**City of Portland, Maine - Building or Use Permit**

Proposed Use: Elementury School / Build new 70,000 sq. Ft. Elementry school. Proposed Project Description: Build New 70,000 sq. Ft. Elementary school.

RFI

**Subject:** Underslab Sanitary Piping

FIGURE REF# 3-B

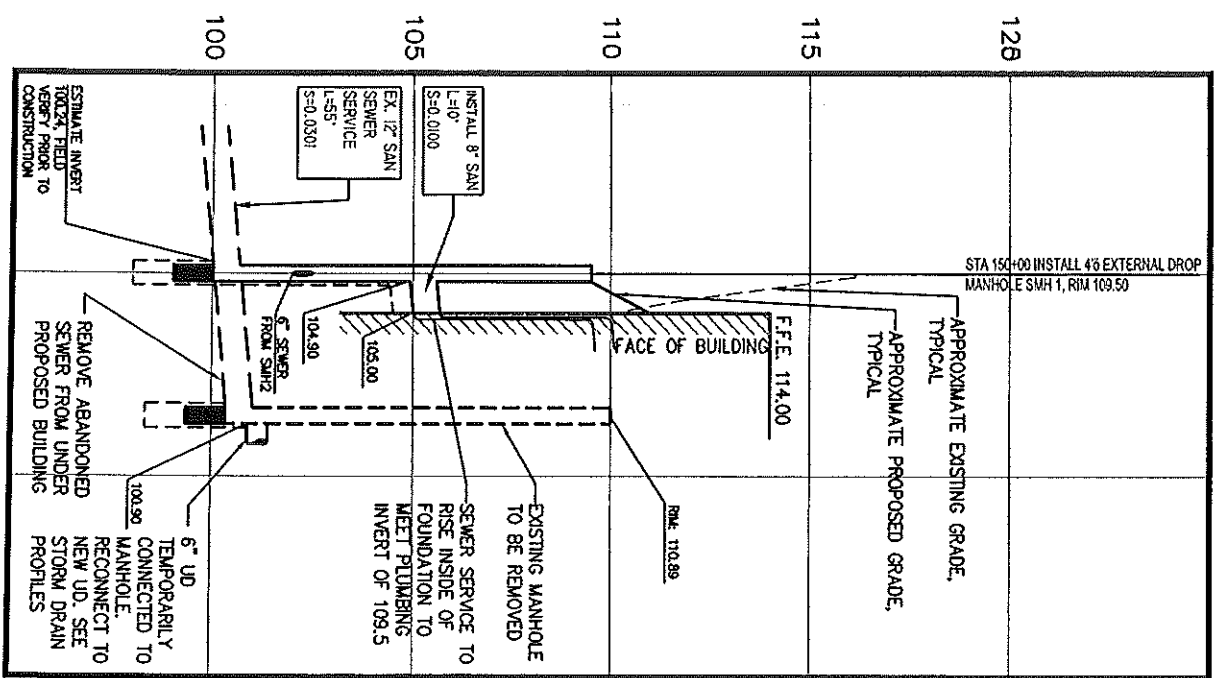
Specifications require 1/4"/ft pitch for the sanitary piping, which based on our distances will result in a trench depth of 93"+/-.  
We are requesting permission to install sanitary piping at a slope of 1/8"/ft. Please confirm.

REVISED SAN SEWER PROFILE 'A' TO ADD  
 SECOND SEWER SERVICE TO SCHOOL.  
 ADDED SAN SEWER PROFILE 'B'

As requested, we have designed for 2 separate sanitary lines leaving the building, to provide 1/4" per foot slope and less deep sewer lines leaving the building.

1. Bill Hoffman of Deluca-Hoffman has provided a cover letter on additional sanitary sewer line and 3 sketches RFI #3A, RFI #3B, RFI #3C all dated 1.20.05. Please coordinate with required elevations on these sketches for the sanitary sewer line to obtain proper protection from freezing.
2. Steve Doel of Bennett Engineering has provided M5R and M6R revised Jan 13, 2005 and showing new location for additional sanitary sewer line. Refer to Hoffman's sketches for required inverts outside of building.
3. We have copied Mike Nugent with 3 sets of drawings for review. He indicated he would forward to Public works and Planning for their review.
4. After your review, please advise us formally if you want to proceed. We will need Mike Nugent's approval also.

Enclosed are three sketches which show the additional sewer service which will lead to the classroom wing. Please note that the sewer will enter the building lower than required by the mechanical engineer. This is to protect the sewer outside of the building from freezing.

FIGURE  
#3-A

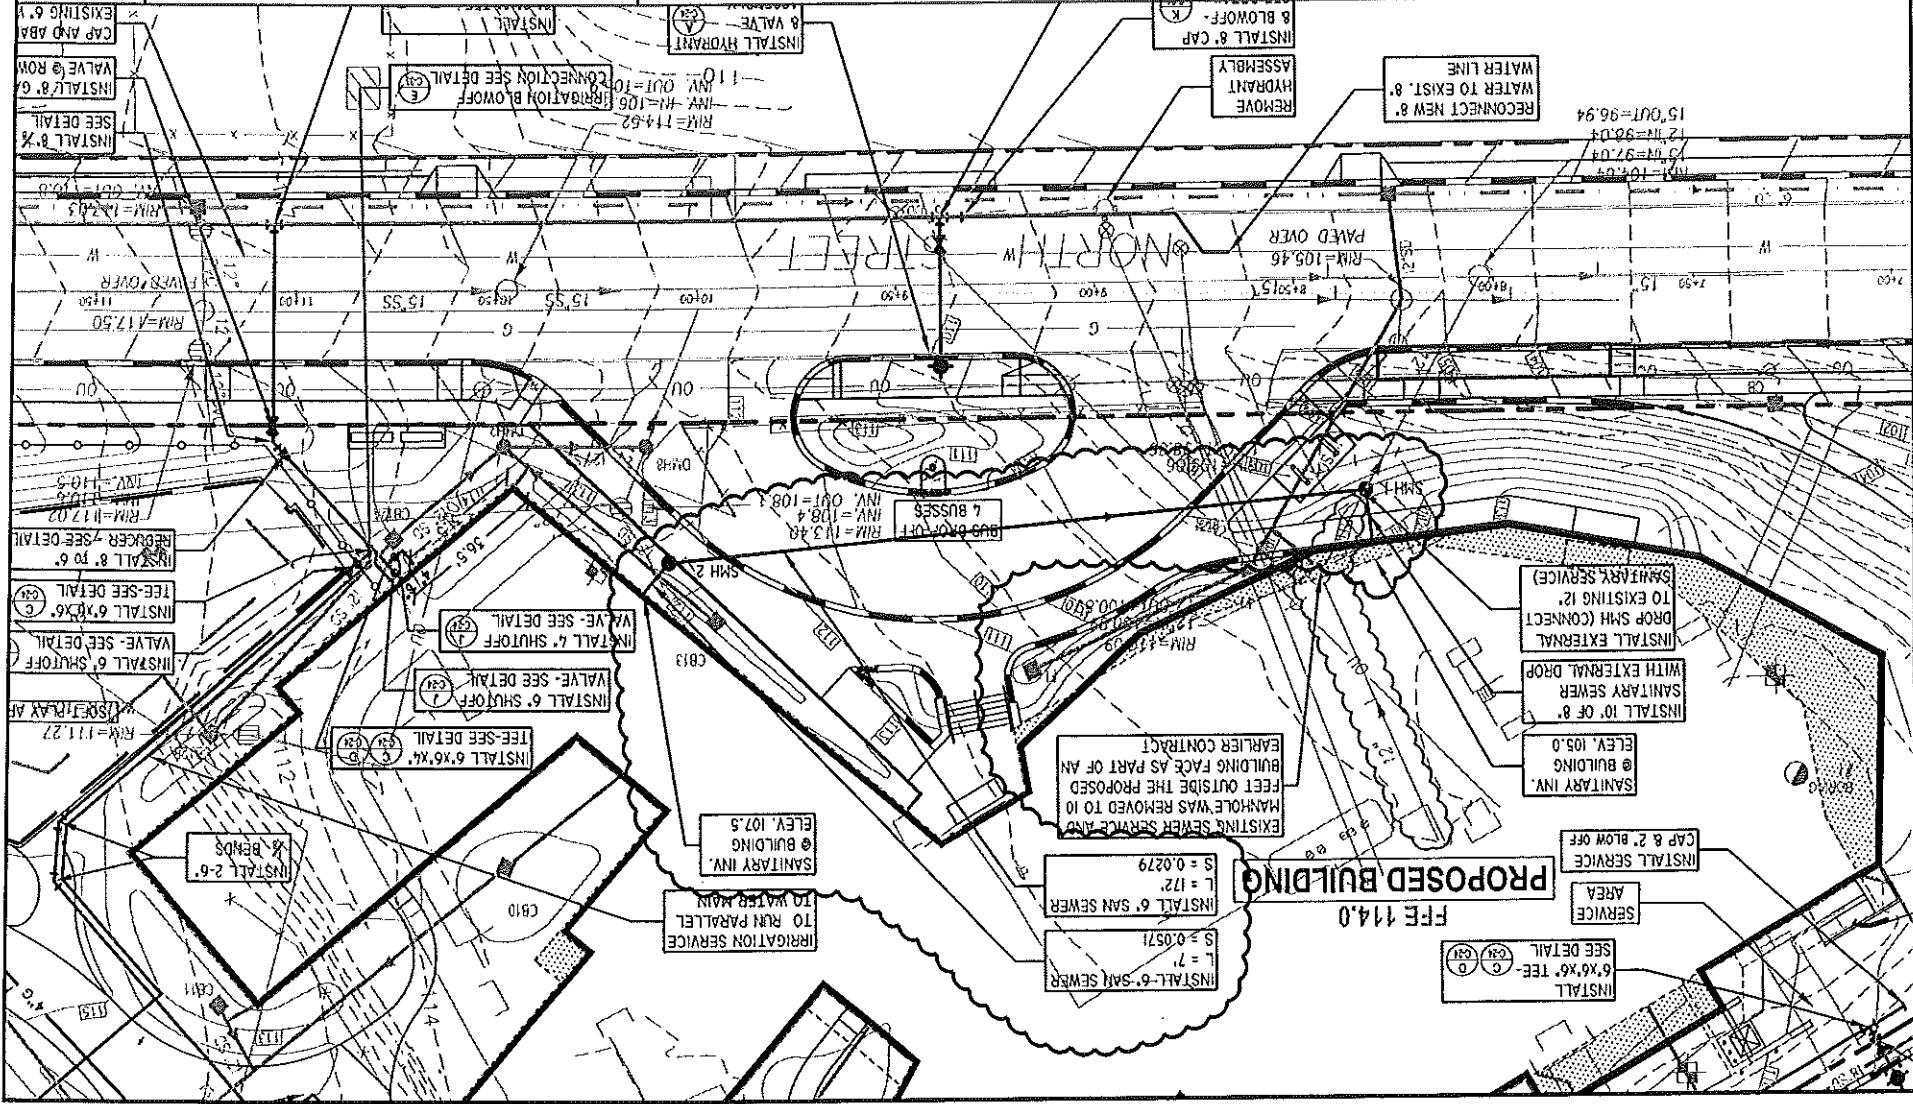
### EAST END ELEMENTARY SCHOOL REVISED UTILITY LAYOUT PLAN TO ADD SECOND SEWER SERVICE TO SCHOOL
